DATE: 03/19/2025

Addendum No. 1

Renovate Interior Corridors Building #1 546-23-112

Miami VA

A204-N

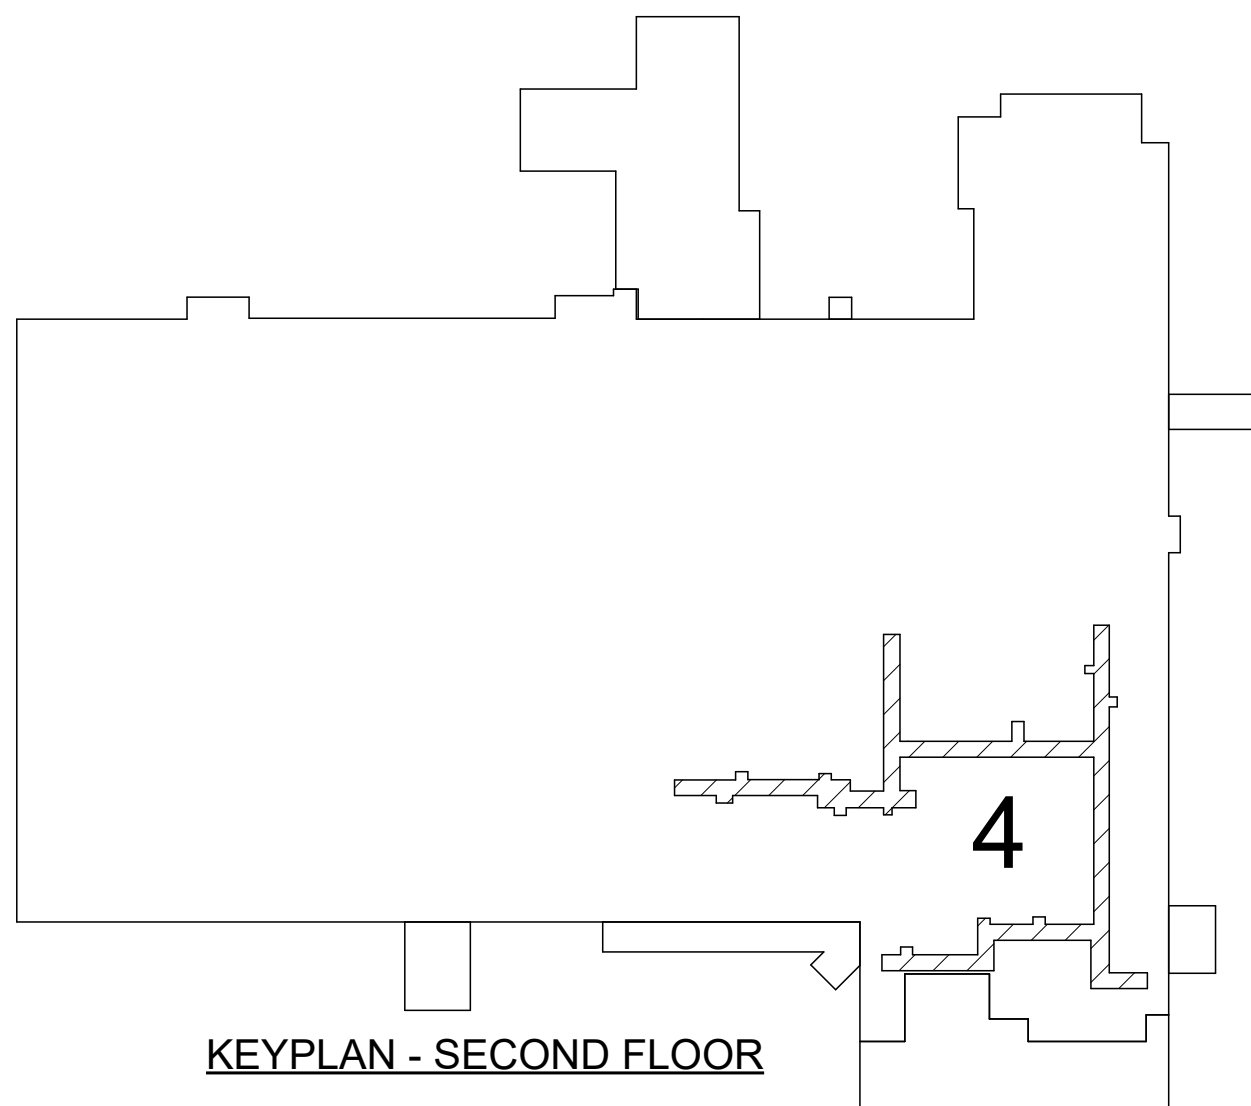
- b. Added enlarged plan B/A201-N room: C2-6-1 on Note Plan.
4. A204-N – NOTE PLAN – SECOND FLOOR
 - a. Added enlarged plans A/A201-N rooms: C2-7-1, C2-28-1, C2-34-1 on Note Plan.

NOTE PLAN - THIRD FLOOR

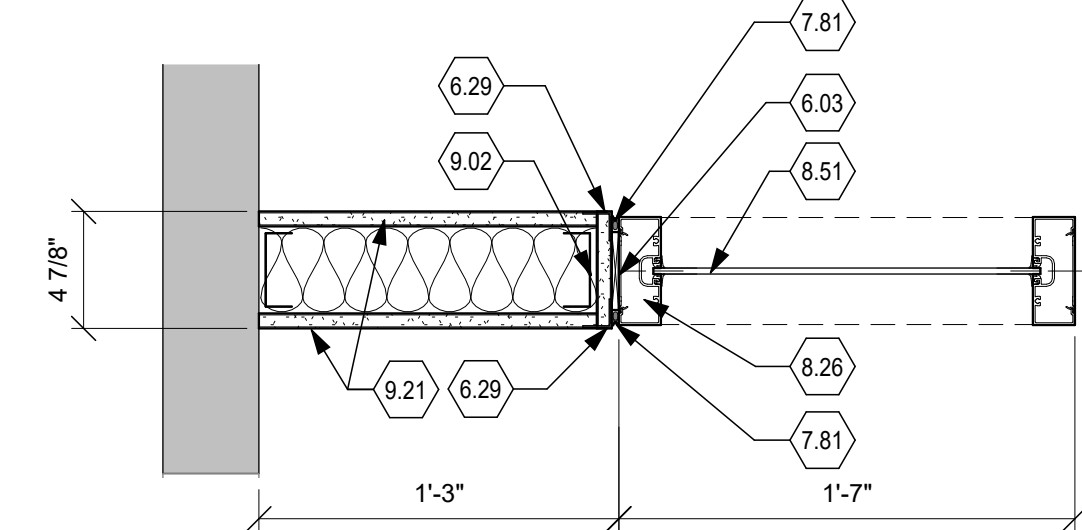
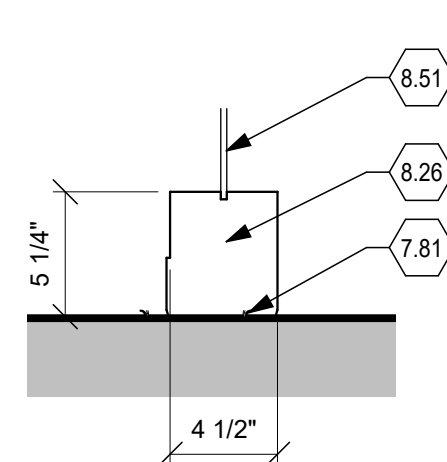
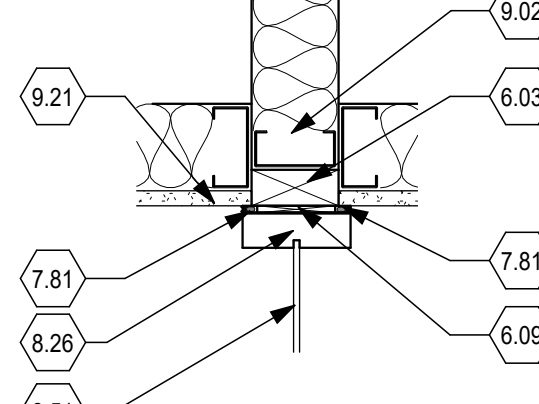
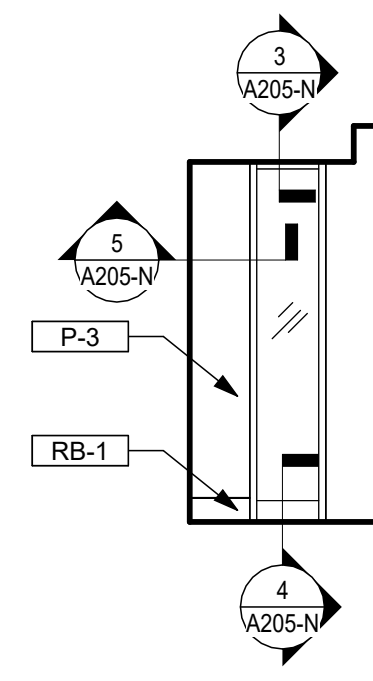
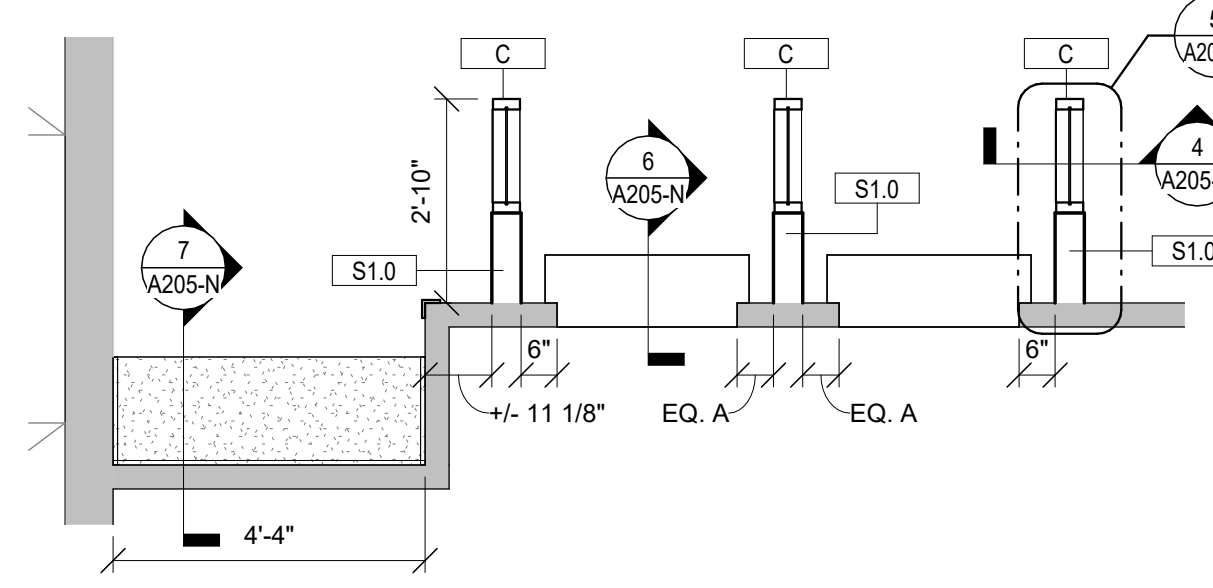
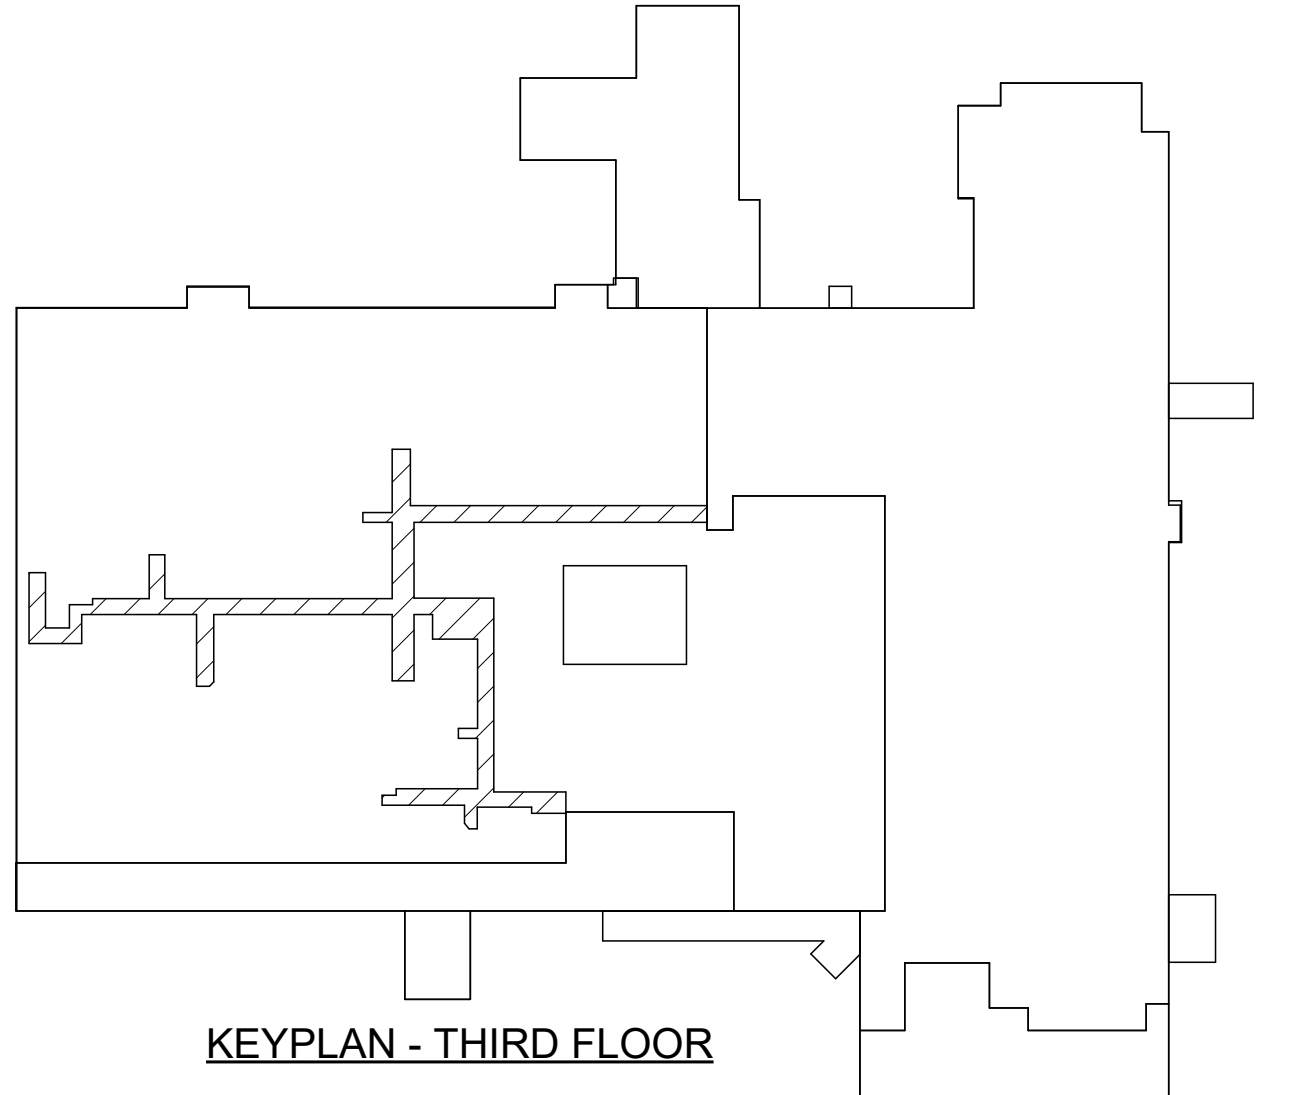
5. A205-N – NOTE PLAN – THIRD FLOOR
 - a. Added detail C/ Enlarged plan.
 - b. Revised detail 2/ Window type “C”.
 - c. Revised detail 3/ Head.
 - d. Revised detail 4/ Sill.

- e. Revised detail 5/ Jamb.

- f. Added detail 6/ Section.
 - g. Added detail 7/ Section.
 - h. Added enlarged plans A/A201-N rooms: C3-3-1, D312A, C3-13-1, C3-1-1 on Note Plan.
 - i. Added enlarged plans B/A201-N rooms: A300, C3-6-1 on Note Plan.
 - j. Added enlarged plan C/A205-N room: D312A on note plan.
- 6. A401 – INTERIOR ELEVATIONS
 - a. Elevations 1, 5, 9: Added signage tags, revised dimensions.
 - b. Elevations 3, 6, 7, 10, 11, 12, 13, 14, 15, 16, 18: Added signage tags.
 - c. Elevation 8: Revised dimensions & solid surface millwork width.
- 7. AF201-F – FLOOR FINISH PLAN – SECOND FLOOR
 - a. Added SS-1 (countertops & custom millwork) to interior finishes legend.
 - b. Added EG-1 (end guard) to interior finishes legend.
 - c. Added General signage notes & sign types.
- 8. AF201-W – WALL FINISH & PROTECTION PLAN – SECOND FLOOR
 - a. Moved details 4 & 5 to sheet A201-N.
